Brookhaven National Laboratory
Plant Engineering - E&CS Division
Engineering Change Notice Form

PROJECT: CCWF II

ECN Title: Women's Locker Room Faucet

ECN No. 36

BNL
 CCWF II
 REF DWG: EP-401
 GIEFELSON
 5-7-10

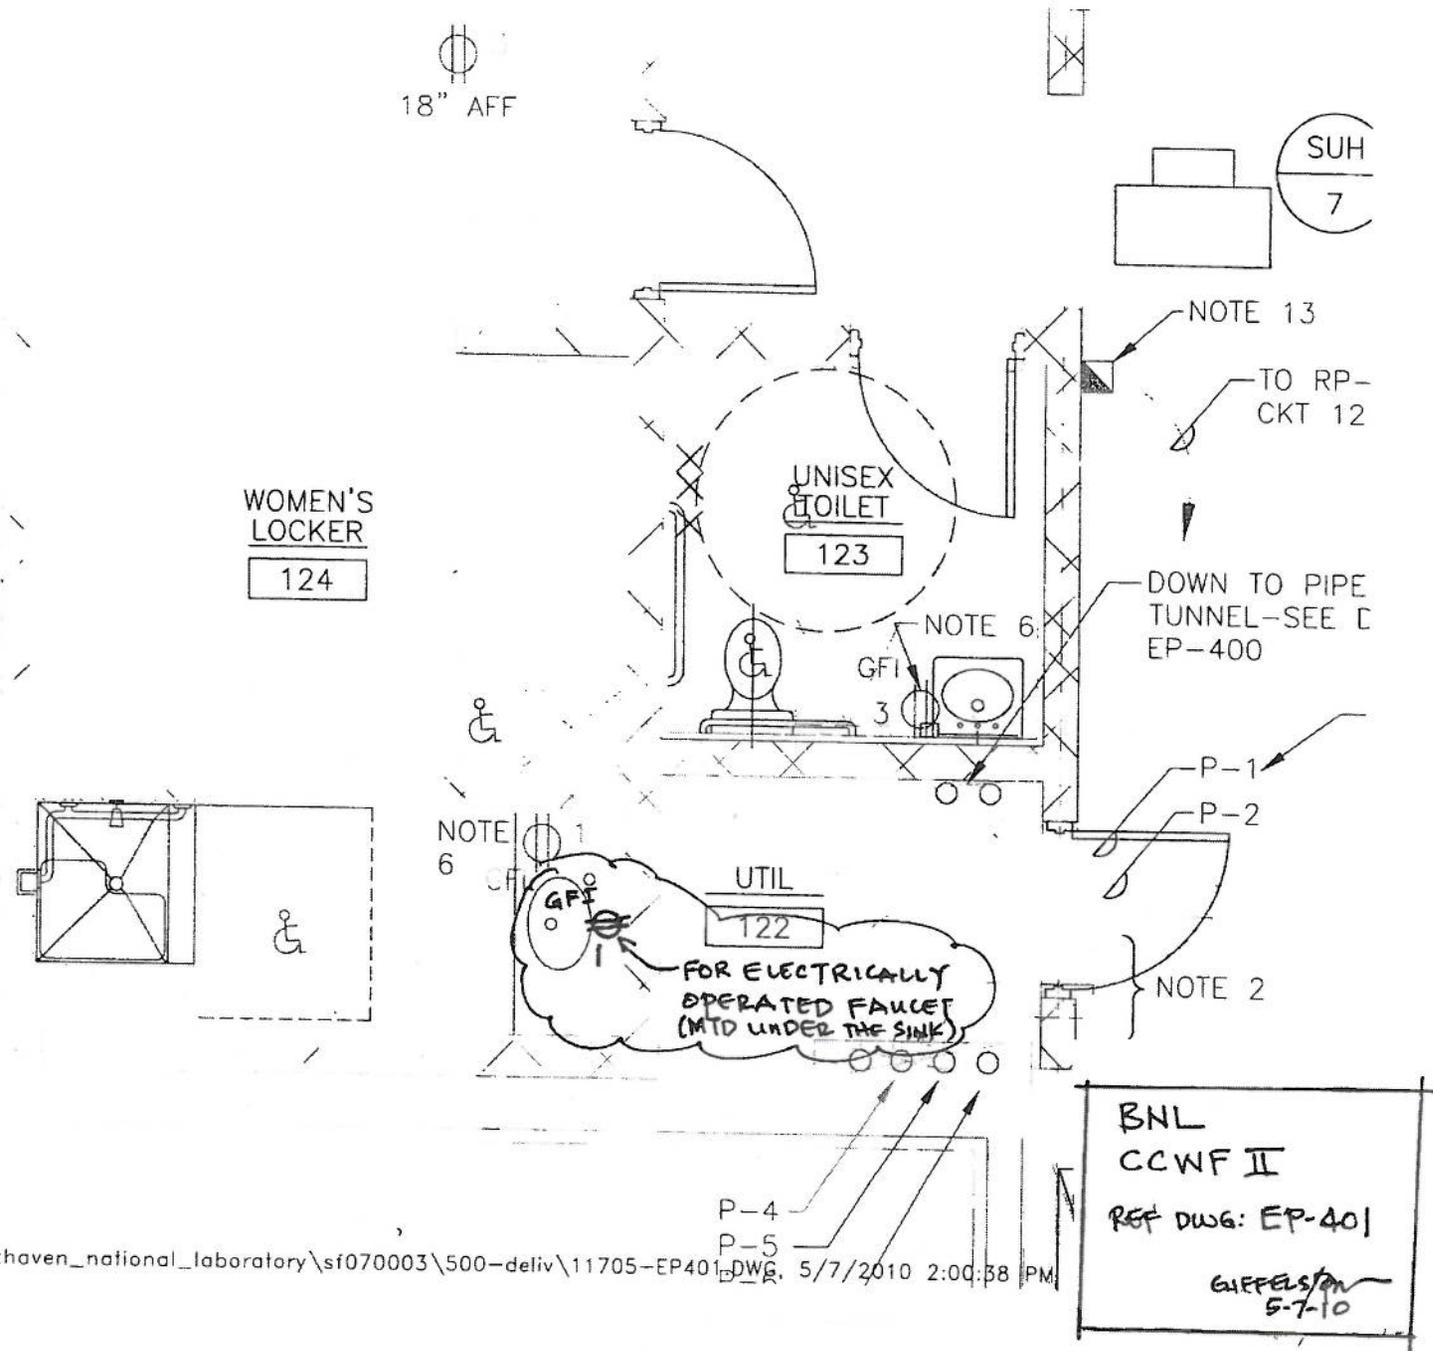
Requested Change (Attach sketch if applicable): Add a 120v GFI outlet under the sink in the Women's Locker Room for the electrically operated faucet

Resolution: See the attached sketch.
